Rebuttal Proof of Evidence – Arboriculture Drawings and Appendices

Brislington Meadows, Bristol
PINS Ref. APP/Z0116/W/22/3308537

Brislington Meadows - Review of FLAC Proof of Evidence – Hedgerow Age

CANDIDATE VETERAN TREE HABITAT CONDITION ASSESSMENT SUMMARY

Drawing Number
D7507.43.003.T5

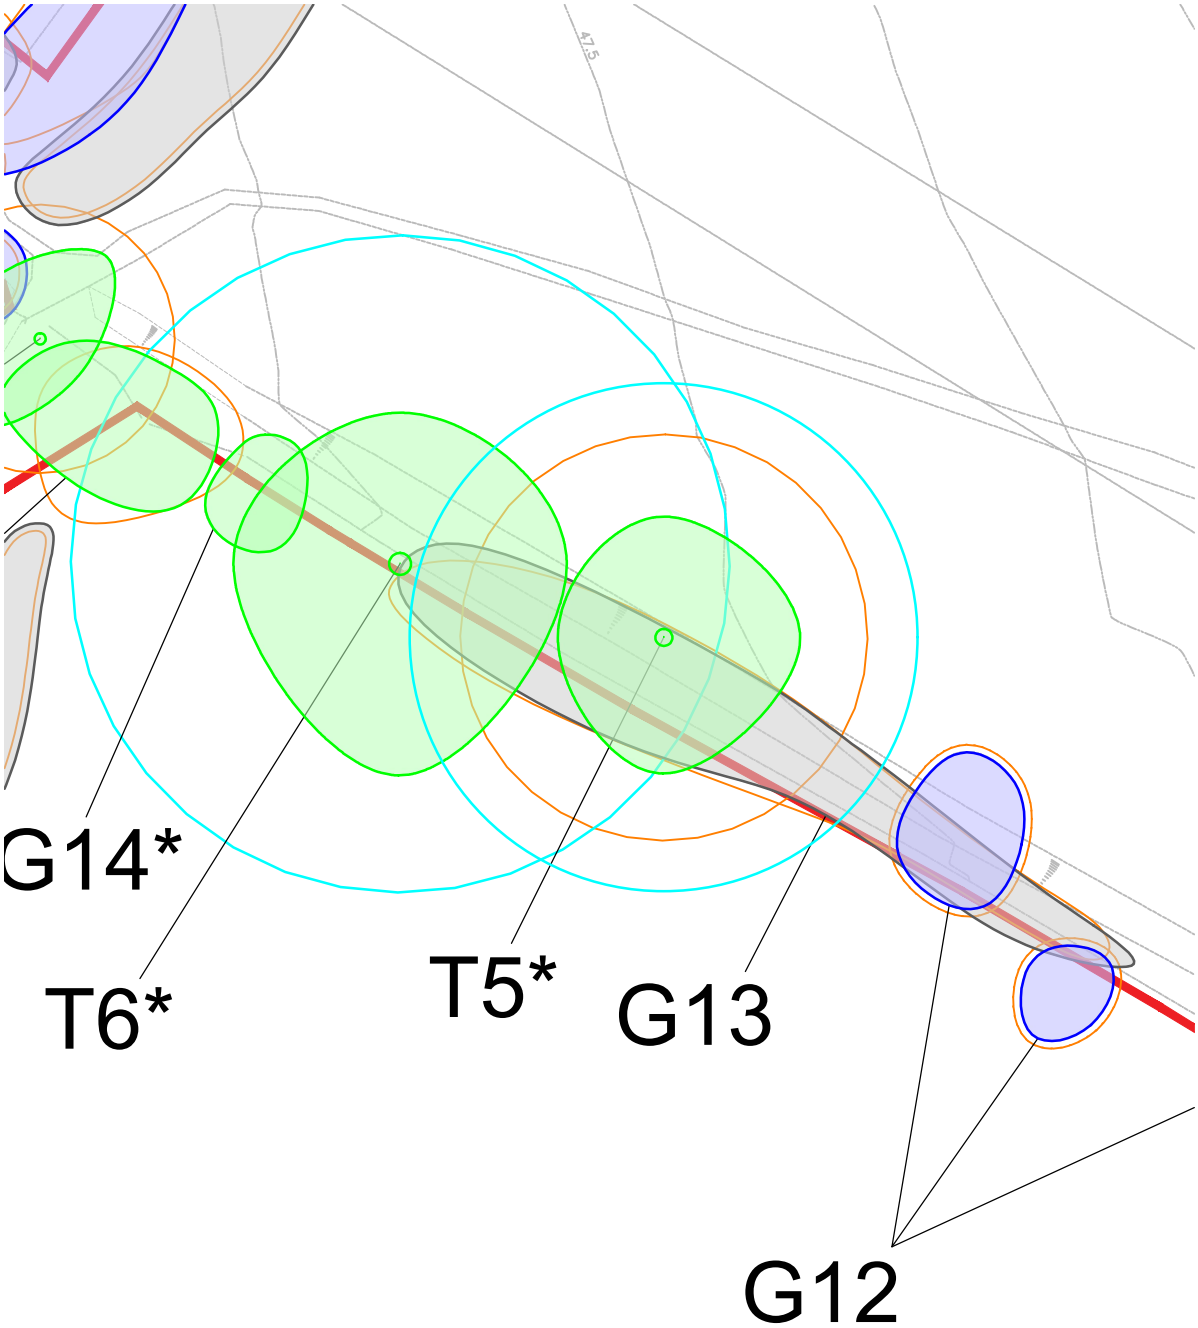
- 5. FLAC Claimed 'Primary Features'
 - Extensive decay
 - Agreed
 - Significant hollowing
 - Agreed
- 6. FLAC Claimed 'Secondary Features'
 - Dead wood>150mm diameter, especially where present in numbers
 - Agreed
 - Dry habitat spaces, especially where present in numbers
 - Not agreed, aerial inspection shows one large cavity is entirely exposed
 - Fungi, especially where present in numbers
 - Perhaps inferred from hollowing but not present or identified

4 criteria claimed. Therefore capable of being a veteran tree on grounds of condition.

Drawing Number
D7507.43.003.T6

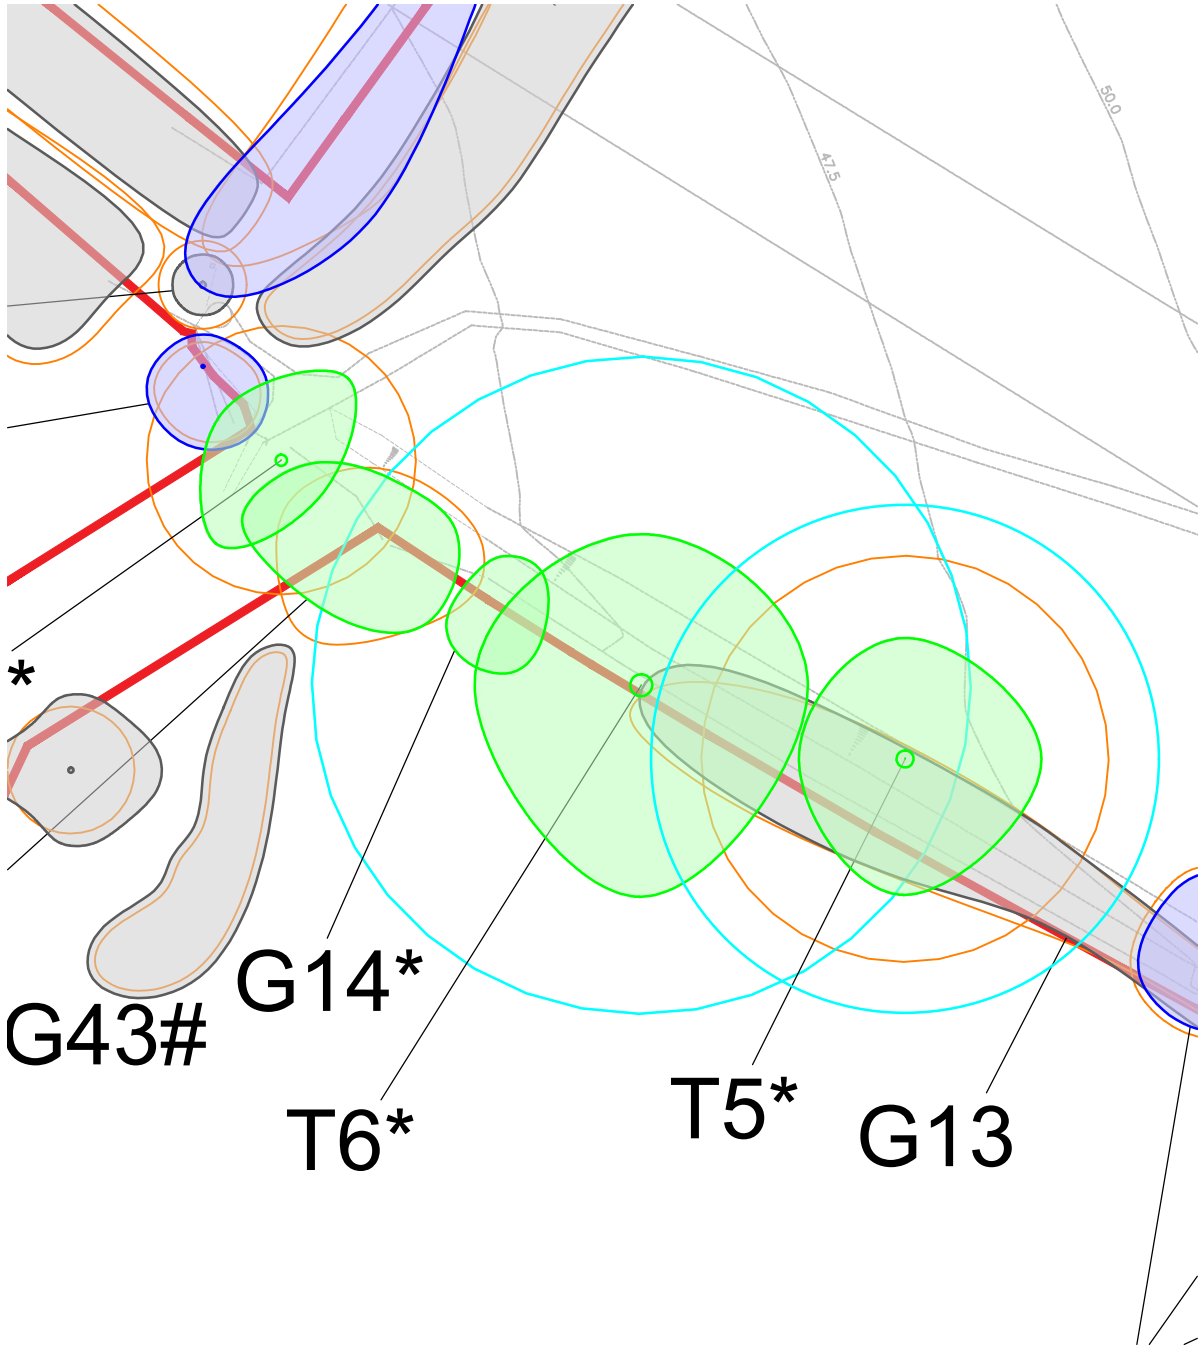
- 5. FLAC Claimed 'Primary Features'
 - Extensive decay
 - Agreed
 - Significant hollowing
 - Agreed likely internal, although not accessible
 - 6. FLAC Claimed 'Secondary Features'
 - Dead wood>150mm diameter, especially where present in numbers
 - Agreed
 - Dry habitat spaces, especially where present in numbers
 - Agreed
- Note:** Fungi not claimed but *Fistulina hepatica* (Beefsteak Fungus) known to be present

4 criteria claimed. Therefore capable of being a veteran tree on grounds of condition.

Drawing Number
D7507.43.003.VH1

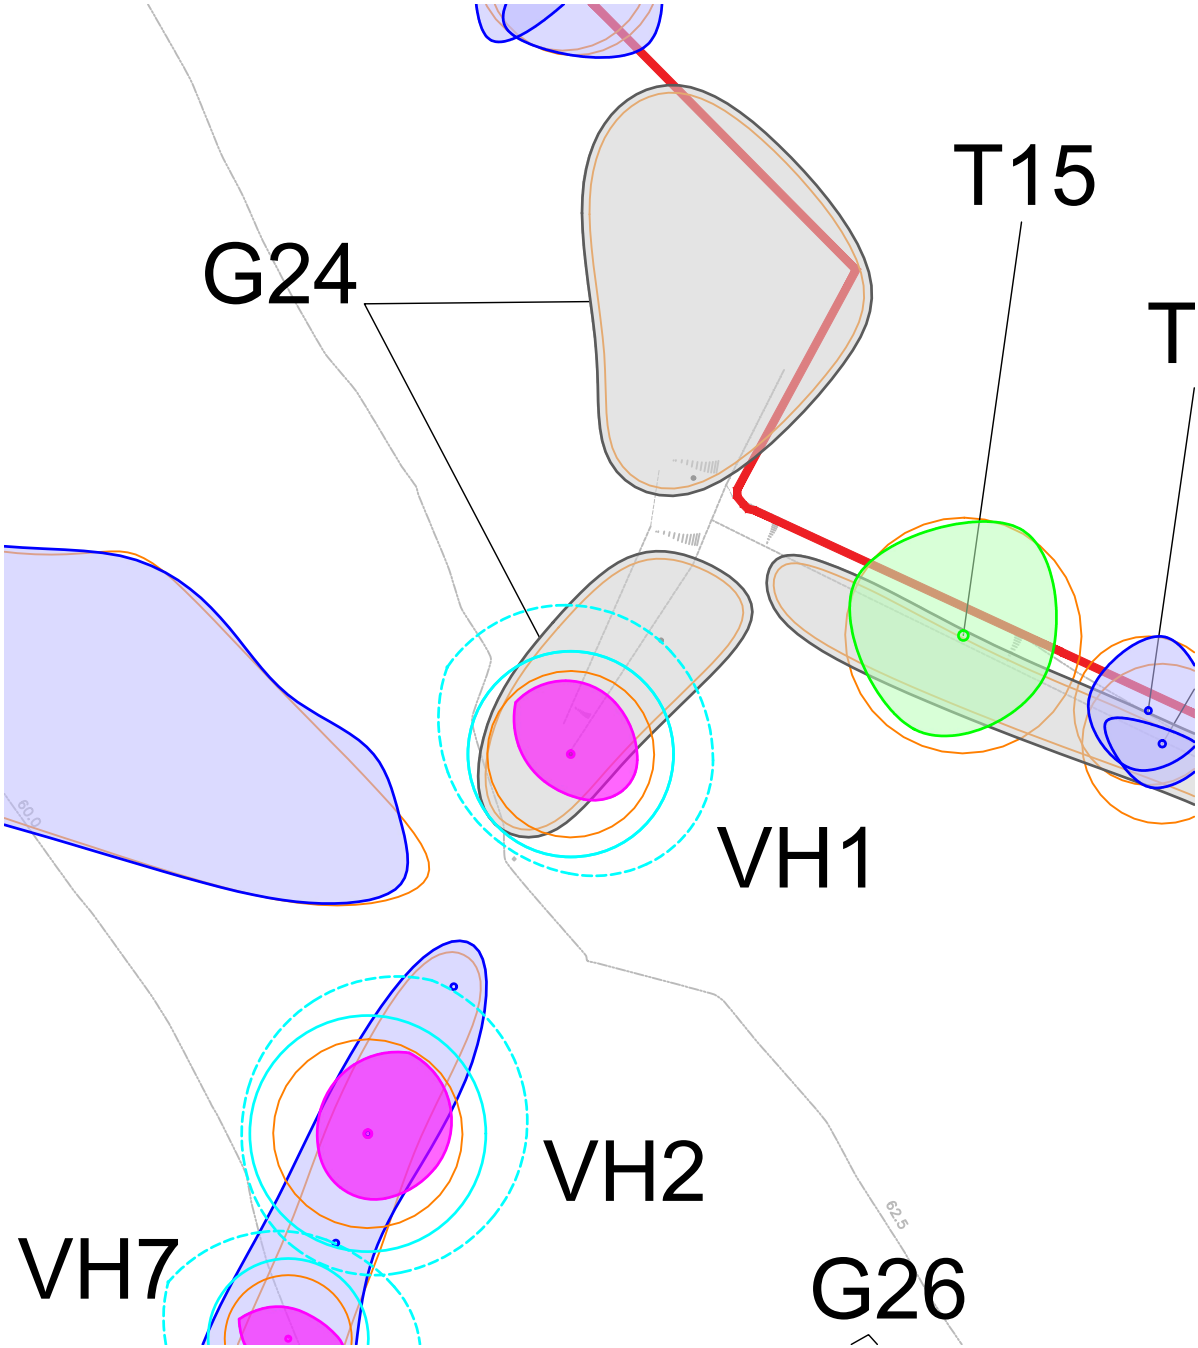
- 5. FLAC Claimed 'Primary Features'
 - Extensive decay
 - Agreed. Most decay is in an elder stem that is not part of the tree. Cumulatively, the quantity of decay just about meets the minimum required.
- 6. FLAC Claimed 'Secondary Features'
 - Dry habitat spaces, especially where present in numbers
 - Not agreed. Only one very small space formed by closing space around lost branch between stems c.5cm in diameter. Very limited.

Only 1 criteria claimed. Therefore not a veteran tree on grounds of condition.

Drawing Number
D7507.43.003.VH2

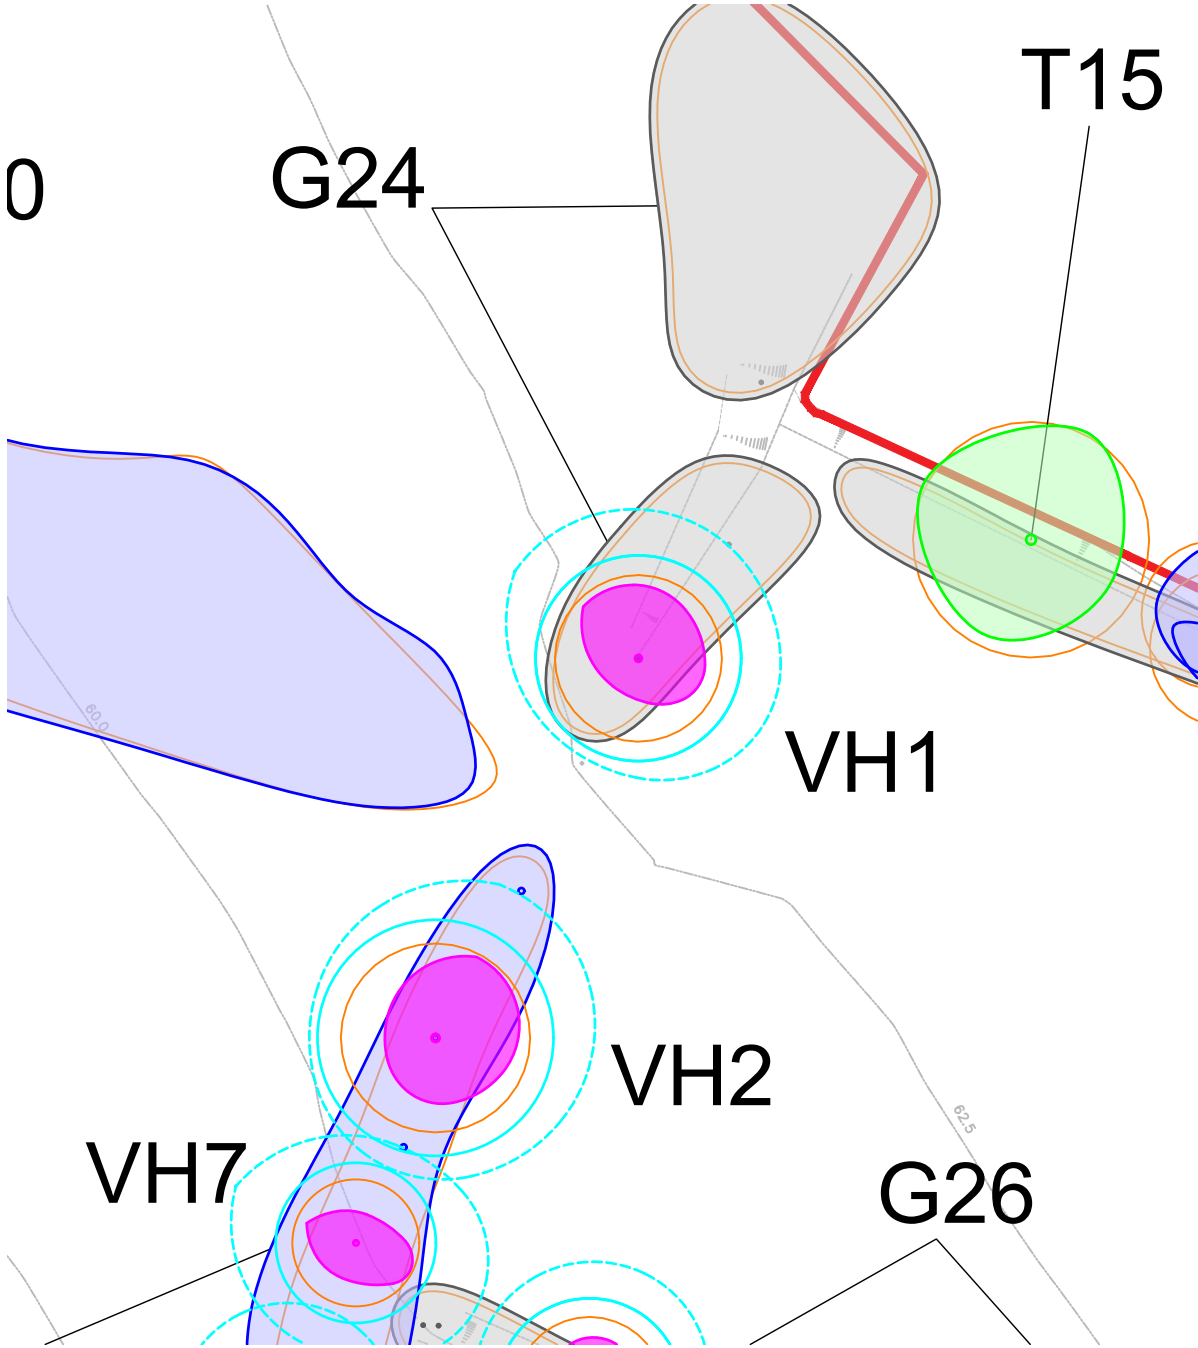
5. FLAC Claimed 'Primary Features'
- Extensive decay
 - Short open socket at the base indicating now absent stem. Inside of opening is largely bark lined and exposed wood area is c.30 x 6cm, which falls short of threshold but agreed in the interests of the most cautious reasonable approach.
6. FLAC Claimed 'Secondary Features'
- Fungi, especially where present in numbers
 - Very small numbers of small saproxylic fungi on bark surface. Fungi is probably *Marasmiellus ramealis* or *M. vaillantii* (both are very common and widespread species).

Only 2 criteria claimed. Therefore not a veteran tree on grounds of condition.

Drawing Number
D7507.43.003.VH3

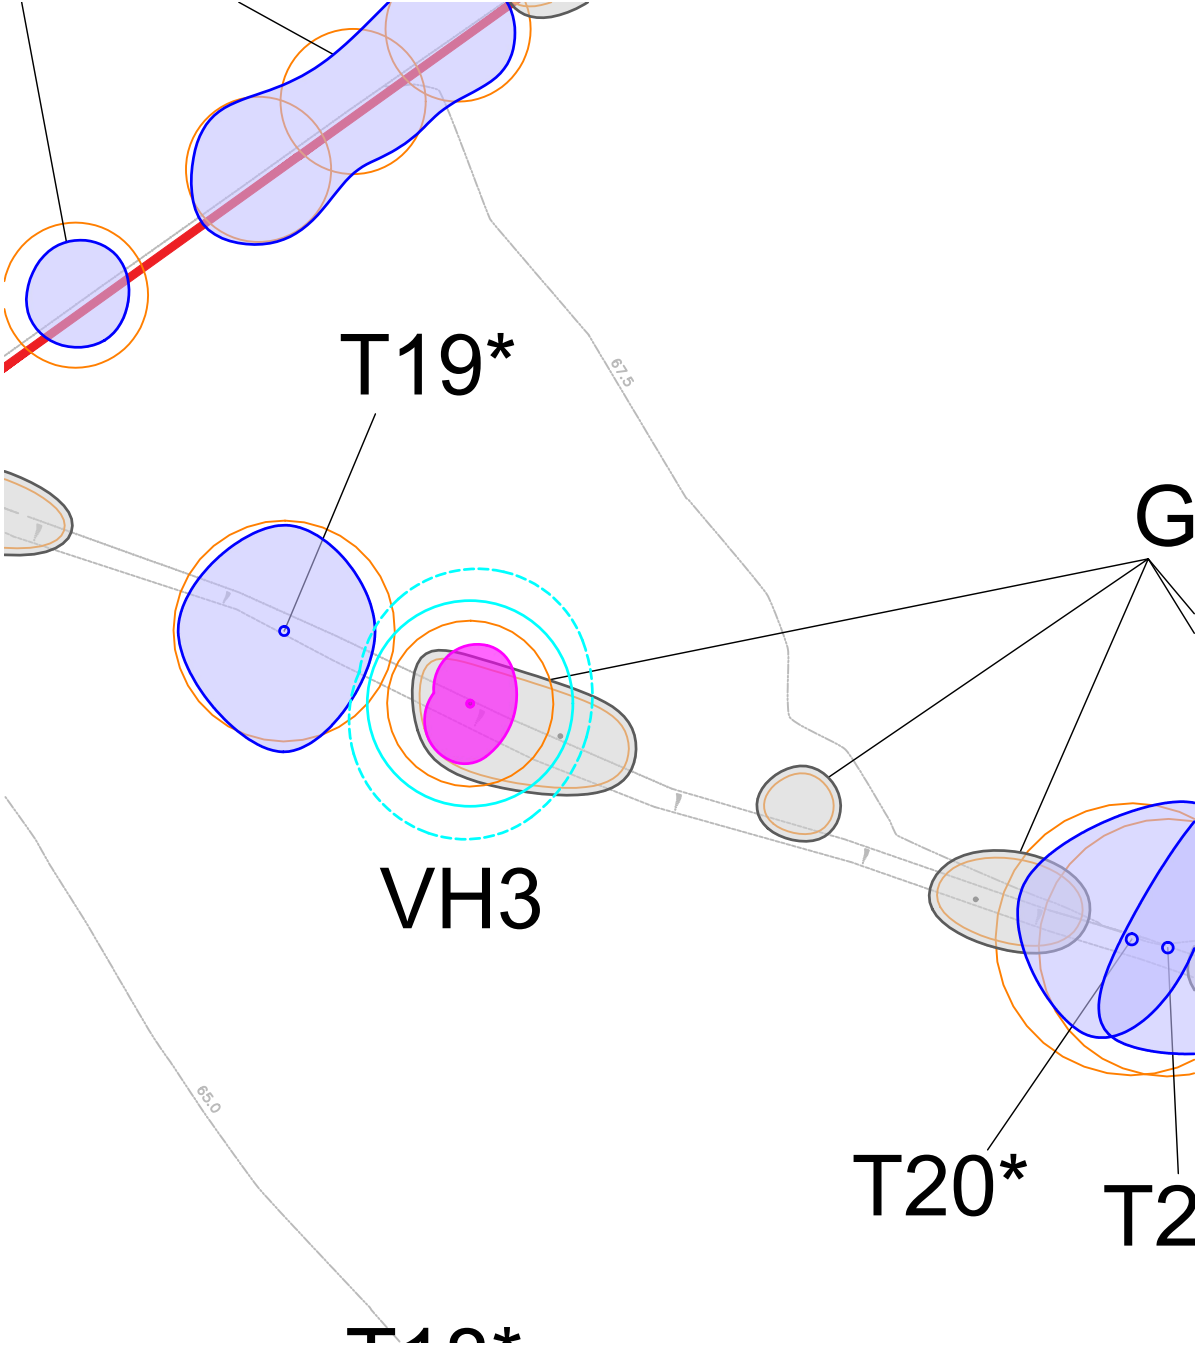
- 5. FLAC Claimed 'Primary Features'
 - Extensive decay
 - Not agreed. One decaying stub at <1m is 25 x 9cm. One fused stub flush with stem is 30x5cm. Limited decay at hedging 'pollard' head of 10cm dia. Aggregating falls short of 400cm² threshold. Decaying wood on ground adjacent not counted.
- 6. FLAC Claimed 'Secondary Features'
 - Fungi, especially where present in numbers
 - Single small fruiting body at branch wound. Agreed in the interests of conservative approach but certainly not present in numbers.
 - Lichens present in significant quantities
 - Not agreed, very limited.

Only 2 criteria claimed. Therefore not a veteran tree on grounds of condition.

Description of Tree - VH4

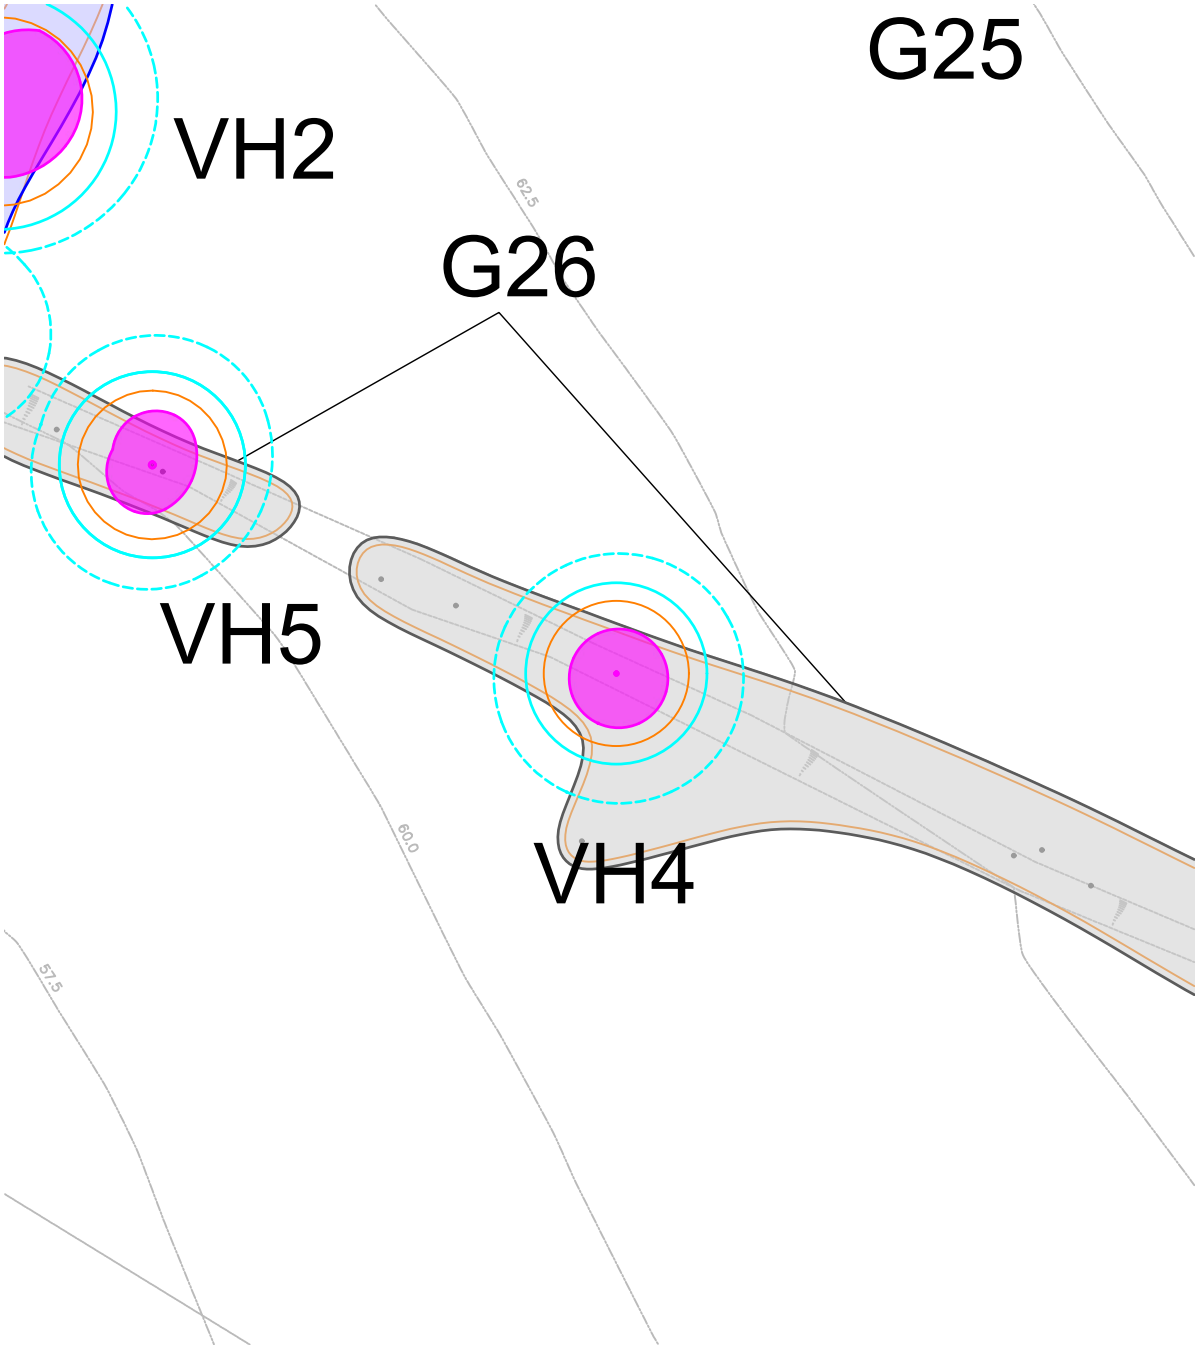
- 190mm
 - 120mm
 - 100mm
4. Diameter at Breast Height (DBH)
- 400mm (1.3m girth)
5. FLAC Claimed 'Primary Features'
- Extensive decay
 - Agreed
6. FLAC Claimed 'Secondary Features'
- Fungi, especially where present in numbers
 - No 'other fungi' identified by FLAC, main interest is in brown rot which is covered by 'extensive decay'
 - Lichens present in significant quantities
 - Not agreed, no significance presence

Only 2 criteria claimed. Therefore not a veteran tree on grounds of condition.
